Model: NAD 30S/30/40		Date: 31-May-98	No: 3
Subject: Service Manual Corrections		Prepared by: Y. Furuya	
From: Technical Service Department.			
Classification:	<input type="checkbox"/> Troubleshooting	<input type="checkbox"/> Part information	<input type="checkbox"/> Action required
	<input type="checkbox"/> Mechanical	<input type="checkbox"/> Electrical	<input checked="" type="checkbox"/> Service manual revision
	<input type="checkbox"/> Paper path	<input type="checkbox"/> Transmit/receive	<input type="checkbox"/> Retrofit information
	<input type="checkbox"/> Other (      )

This bulletin contains corrections for the Fax Option Type 450 service manual.

## Chapter 3

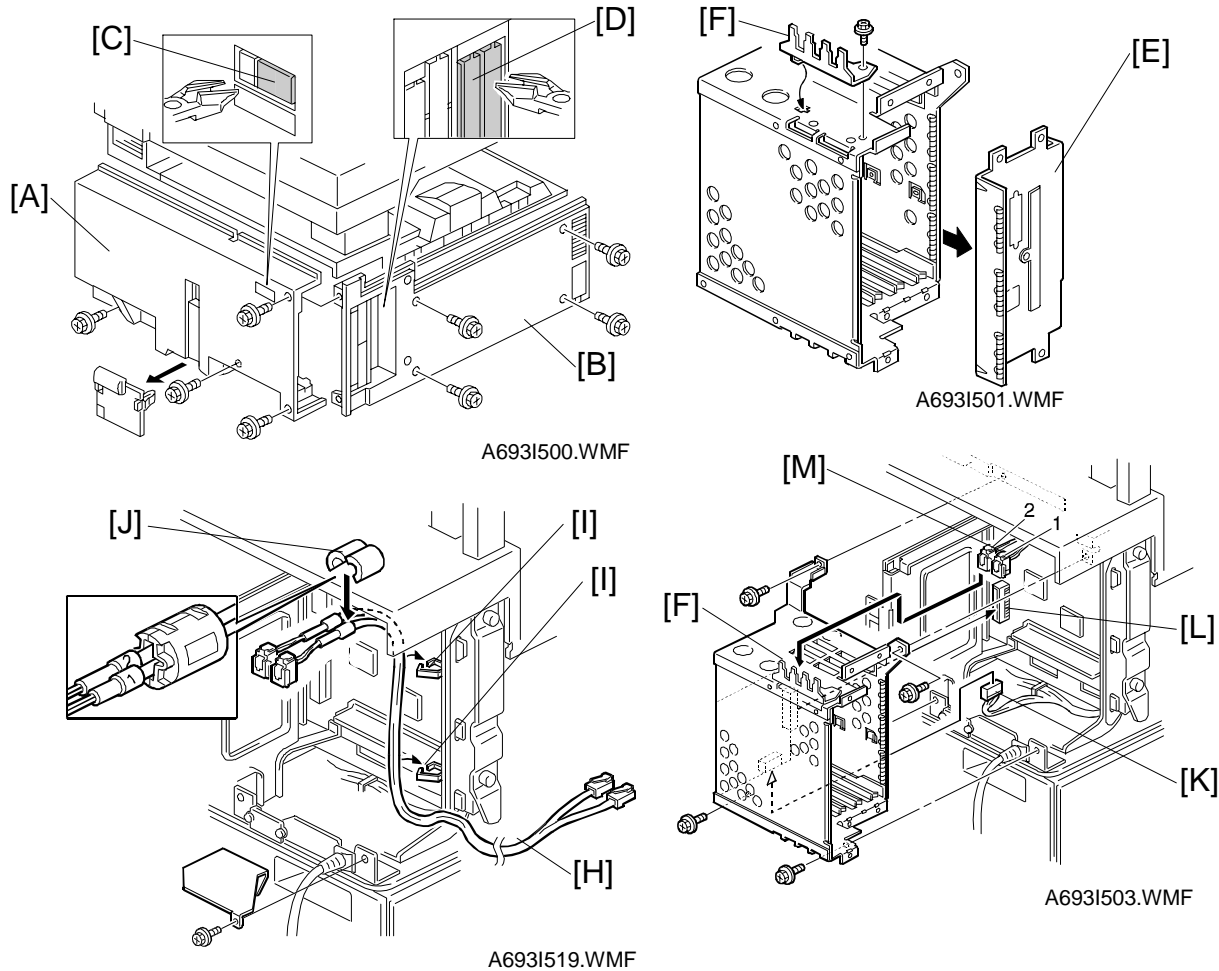
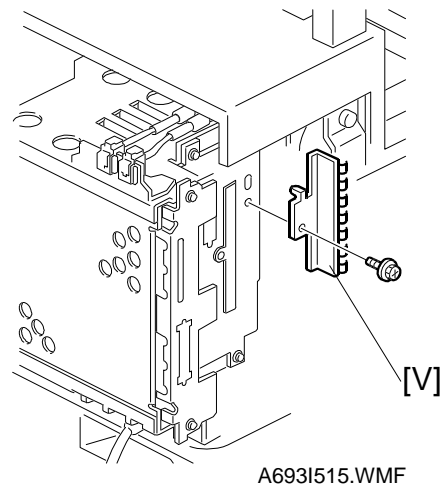
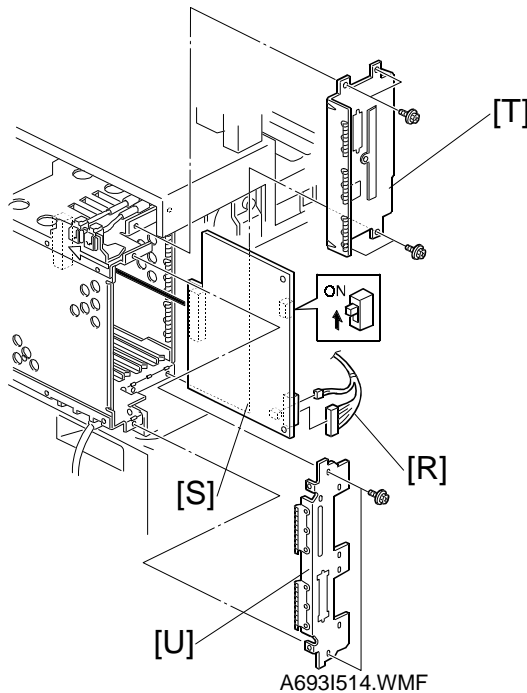
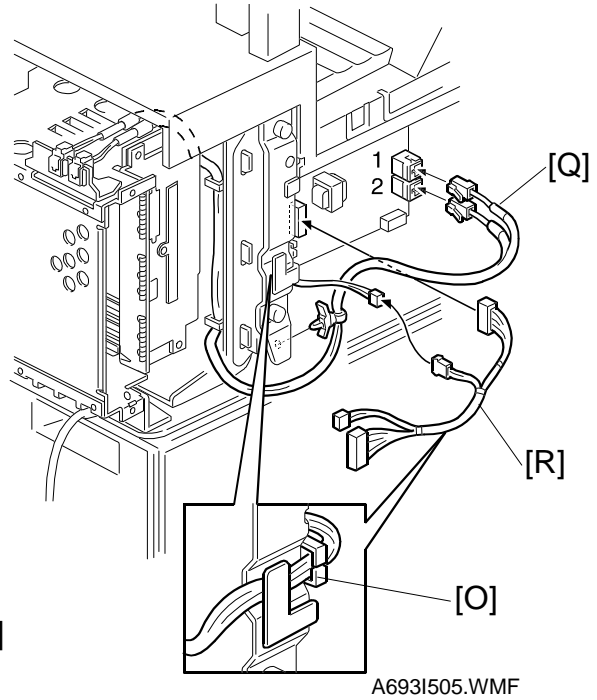
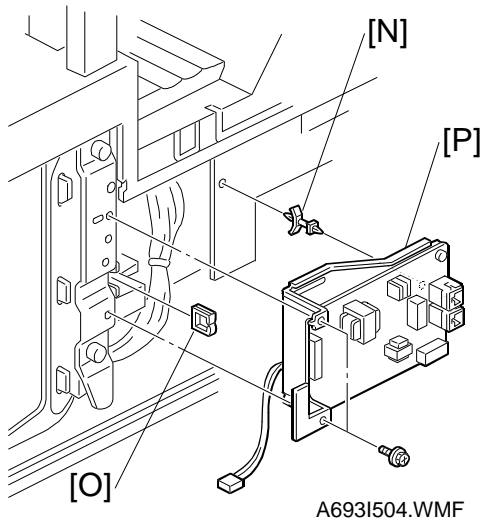
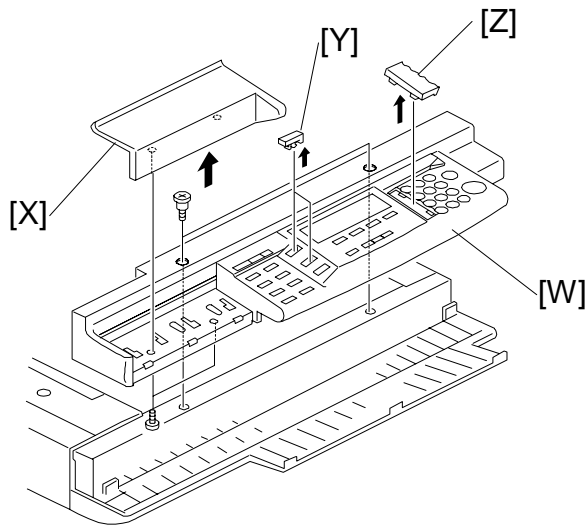
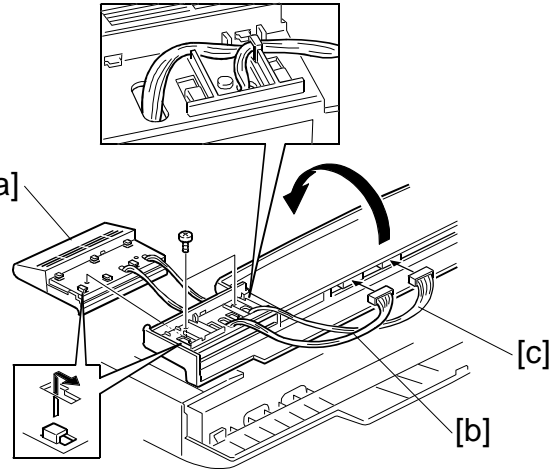
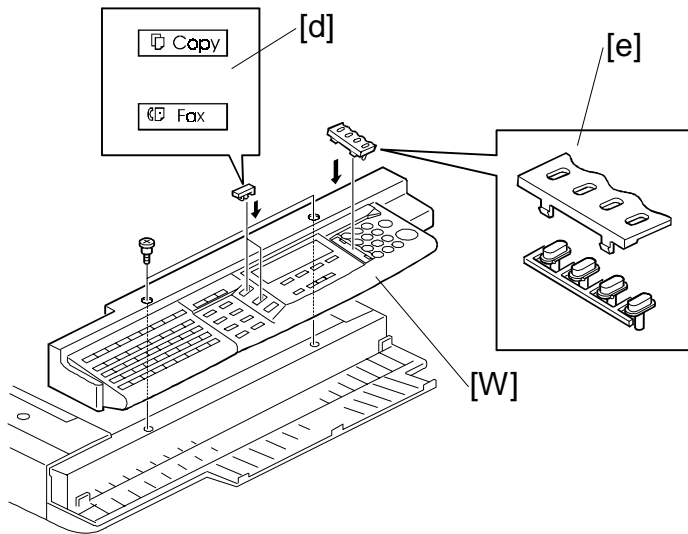
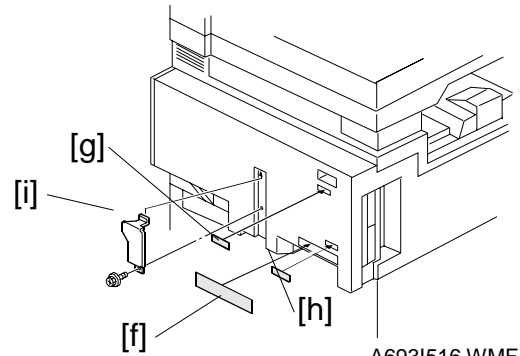
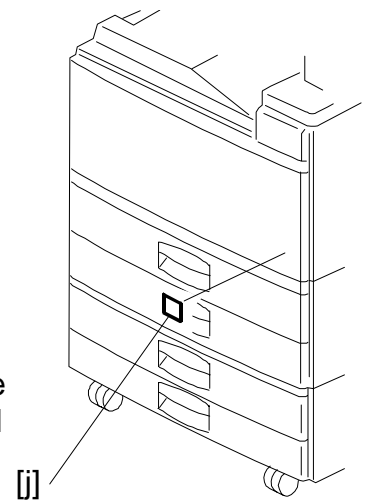
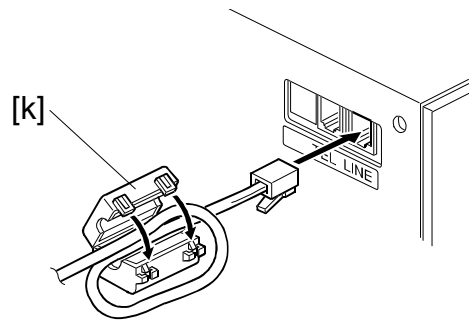
- 1) The installation procedure was not suitable for the Taiwan version
- 2) A bracket must be removed before installing the expansion box; this was not mentioned.
- 3) The procedure for attaching the PTT approval label was missing.

- 1) The installation procedure has been modified for all versions, including Taiwan.
- 2) Missing steps have been added. (Items 2 and 3 above; refer to pages 2 to 5.)

1. Remove the rear cover [A] (4 screws) and the left side cover [B] (4 screws), as shown.
2. Cut away the covers [C] and [D] (shaded parts), as shown.

**NOTE:** If installing the fax hard disk option at the same time, refer to the hard disk installation procedure before going on to the next step.
3. Remove the cover [E] from the expansion box, then install the FCU cover bracket [F] (1 screw) as shown.

**NOTE:** The bracket [F] is included in the fax unit.
4. Remove the bracket [G], and run the cable [H] through the clamps [I], then install a metal core [J] as shown.

**NOTE:** The metal core [J] is not installed the model for Taiwan.
5. Connect the harness [K] to CN355 on the expansion box, then install the expansion box (4 screws) so that the CN350 fits in CN304 [L] on the BiCU.

**NOTE:** Use a magnetic screwdriver so as not to drop any screws inside the machine.
6. Attach the modular jacks [M] to the bracket [F] as indicated on the bracket.

7. Set the locking support [N] and the edge saddle [O] as shown, then install the NCU/Speaker assembly [P] (2 screws).
8. Connect the cable [Q] and the harness [R] as shown. The harness [R] must run through the edge saddle [O] as shown.
9. Turn on the battery switch (SW1) on the FCU [S] then set it in the right-most slot of the expansion box as shown. Connect the harness [R] to the FCU (CN328 and CN330), then slide the FCU [S] all the way in (1 connector).
10. Install the brackets [T] (3 screws), [U] (2 screws) and [V] (1 screw) as shown.  
**NOTE:** The bracket [U] is installed only in the model for Taiwan.

11. Remove the operation panel [W], then remove parts [X], [Y], and [Z].
12. Install part [a], then connect the harnesses [b] and [c] to the operation panel as shown.
13. Replace the operation panel [W], then install the parts [d] and [e], as shown.
14. Replace the left side cover (4 screws) and the rear cover (4 screws).
15. Affix the serial number label [f], the LINE/TEL label [g] and the appropriate approval label [h] onto the rear cover. Then install the bracket [i] (1 screw).
16. Attach the "Super G3" label [j] to the front cover.
